New Zealand Transport Agency

Whirokino Trestle and Manawatu River Bridge Replacement
Post Construction Road Safety Audit

July 2021

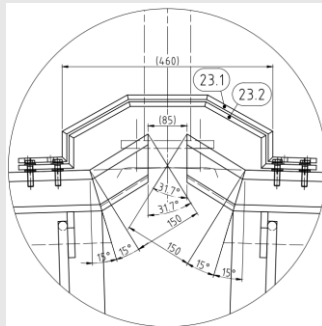
The mountable kerb (concrete nose and metal side covering) at the expansion joint is a hazard. Impacts to the kerb nose (particularly when adjusted for barrier posts) and sides by errant motorcyclists or vehicles could cause harm, however infrequent they may be.

Consider developing options that remove the need for a mountable kerb or cover.

Novare: The cover plates are provided to mitigate the safety hazard caused by the upstands in the expansion joint as shown in the sketch below. The mountable kerb is provided to mitigate the hazard further. The kerb or plate cannot be removed as it will create a further safety issue.

The length of the mountable kerb can be increased along road centreline to increase the transition length of the mountable kerb and mitigate the impact risk.

BBO: Extending the mountable kerb nose will require relocation of the barrier posts. As discussed in 2.1.1 above, the existing system should perform adequately when impacted by cars. For motorcycles to hit the kerb they will already have impacted the WRSB so outcomes will already be severe. Propose no change be made.

Safety Engineer	Considering the overall length of the barrier and the relatively short length of mountable kerb, the risk is low that it will be struck and if struck the risk will be low that the system will fail.
Client Decision	Agree with BBO and Safety Engineer's responses. No further action required.
Action Taken	N/A

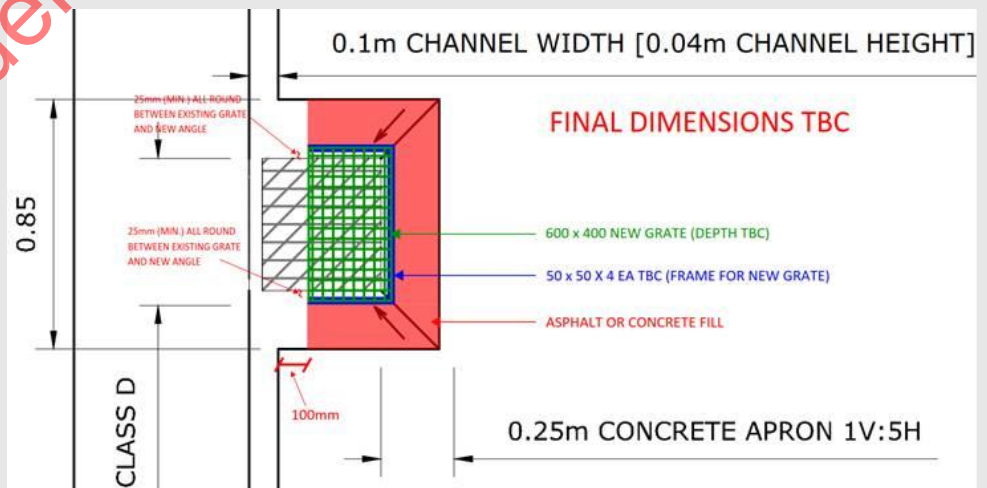
Sumps along the sealed shoulders of the bridges are located approximately 50 mm below the seal surface. On the Moutoa Floodway Bridge (Whirokino) sumps are spaced approximately every 50 m. “Confident and courageous” type of cyclists will use the shoulder rather than the shared path. The dips at 50 m spacing will create an uncomfortable ride for cyclists who consistently use the shoulder, and will cause them to ride on the non-undulating surface closer to the traffic lanes, increasing their risk.

Consider a sump solution level with the surfacing.

Designer Response: *Novare:* A solution has been proposed. If we get a go-ahead from everyone, we can start working on the details.

BBO: The Contractor has also been asked to investigate using a concrete planer to reduce the slopes surrounding the sump, as an alternative to the above solution. If feasible, this would be preferred by BBO.

Safety Engineer	In deciding between the two options, the Novare solution would be superior with respect to cyclist comfort. Rising the grate would also deal with the issues in 2.6.1 where Novare recommends raising the sump grate height to deal with the likelihood of the drain blocking due to debris.
Client Decision	Agree with the Safety Engineer's response. Given the shoulder width is only 1.5m, from a safety perspective, the full width needs to be available for cyclists at all times and at present, this is not the case. Furthermore, the planning option (without raising the level of the sump grate) is really only a partial mitigation measure as the perceived hazard still remains. Very careful thought needs to be given to the final solution, as any works will result in delay and disruption to road users and is likely to attract negative feedback if the comms are not handled appropriately.
Action Taken	June 2021 update: Grates have been raised level with the road surface. No further action required.
